NAUTICAL POINTE SUBDIVISION

APPLICATION NUMBER 20 DATE January 3, 2008

DETAIL SITE PLAN

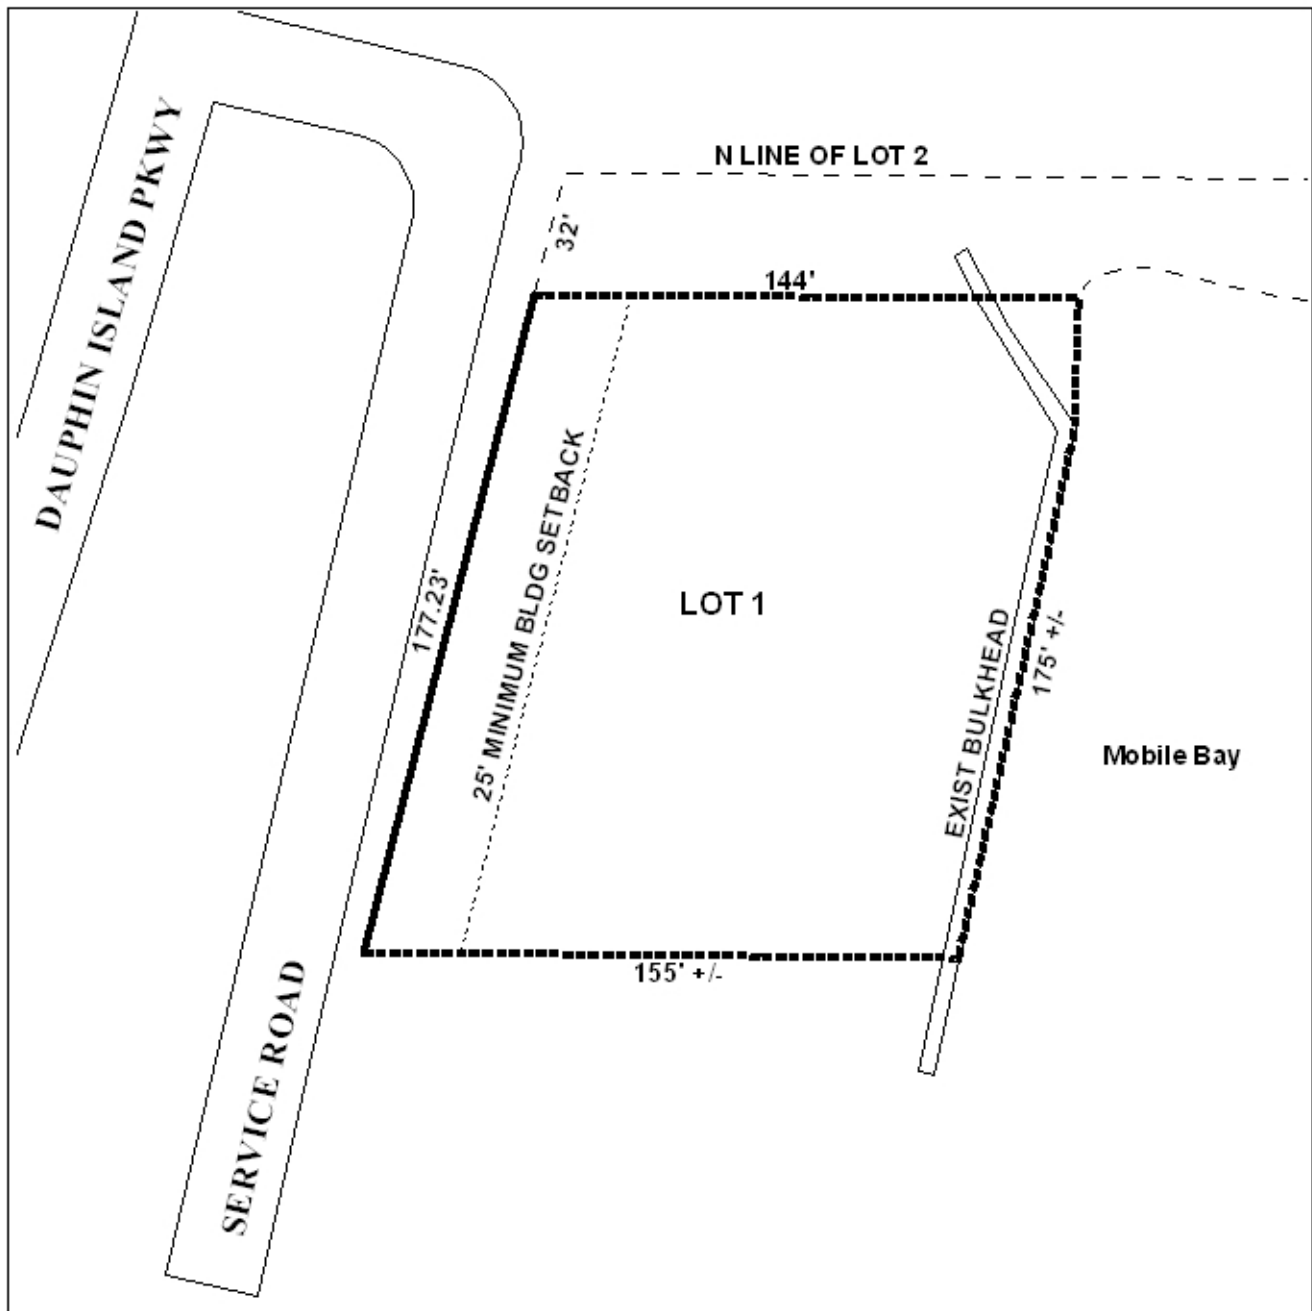
Engineering Comments: Show minimum finished floor elevation on the lot as 12.77' on plat, which is one foot above the Hurricane Katrina high water elevation in the area. No fill or grading allowed in VE zone, per FEMA regulations; add note to the plat to this effect. It is the responsibility of the applicant to look up the site in the City of Mobile (COM) GIS system and verify if NWI wetlands are depicted on the site. If the COM GIS shows wetlands on the site, it is the responsibility of the applicant to confirm or deny the existence of wetlands on-site. If wetlands are present, they should be depicted on plans and/or plat, and no work/disturbance can be performed without a permit from the Corps of Engineers. Must comply with all storm water and flood control ordinances. Any work performed in the right of way will require a right of way permit.

The site was approved for a one lot subdivision in 2005 and extended in 2006; but it expired in August 2007, hence this application. However the legal description has changed since the last application to exclude 32' along the service road at the Northern part of the proposed lot. The total excluded portion of the lot is approximately 4600 square feet. It is recommended that the plat be revised to include the remainder of the metes and bounds parcel in the subdivision process.

The plat meets the minimum size requirement for developments with access to public water and sewer. However, it is requested that the applicant revise the preliminary plat to label the lot with its size in square feet, or provide a table on the plat with the same information.

Based on the preceding, this application is recommended for a holdover to allow the applicant to submit a revised plat including the remainder of the metes bounds parcel in the subdivision.
